UNITED STATES
DEPARTMENT OF THE INTERIOR
BUREAU OF LAND MANAGEMENTFORM APPROVED
OMB NO. 1004-0137
Expires: January 31, 2018**SUNDRY NOTICES AND REPORTS ON WELLS**
*Do not use this form for proposals to drill or to re-enter an abandoned well. Use form 3160-3 (APD) for such proposals.*Field Serial No.
NMCC032450A**SUBMIT IN TRIPLICATE - Other instructions on page 2**

Occidental Permian LP - Current
 South Mattix A Federal #5
 API No. 30-025-11201

Conditions of Approval for Temporary Abandonment of Wells

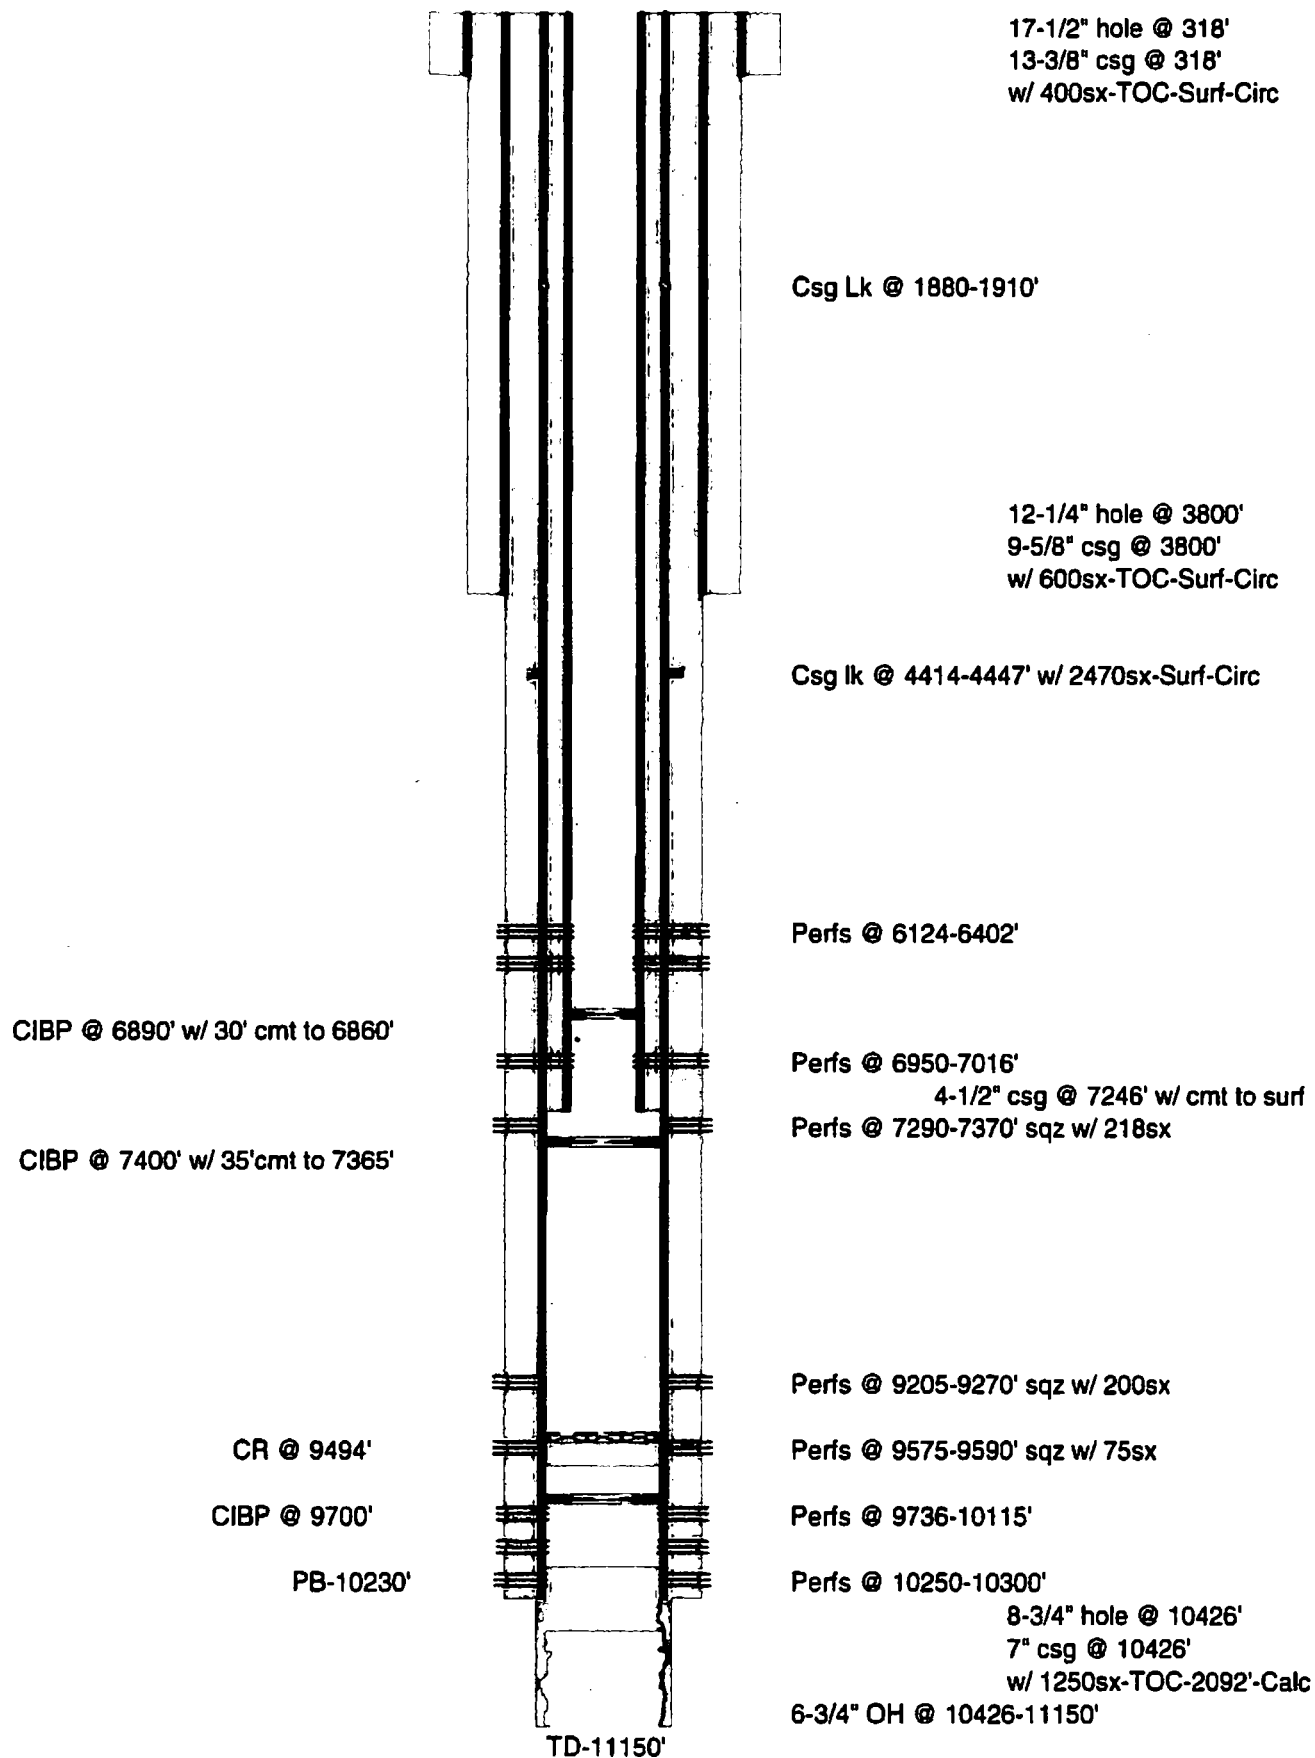
1. A bridge plug (CIBP) must be installed 50 to 100 feet above any open perforations or open hole. The CIBP must be capped with either a minimum of 25 sacks of cement if placed with tubing or 35 feet of cement if placed with a bailer. The top of the cement must be verified by tagging.

2. The wellbore must be filled with corrosion inhibited fluid and pressure tested to 500 psi. The casing shall be capable of holding this pressure for at least 30 minutes. If the well does not pass the casing integrity test, then the operator shall, within 30 days, submit a procedure to either repair the casing or to plug and abandon the well.

4. All downhole production/injection equipment (tubing, rods, etc.) shall be removed from the casing if it is not isolated by a packer.
5. A bradenhead test must be conducted. If the test indicates a problem, a remedial plan and time frame for remediation shall be submitted within ninety (90) days of the test.
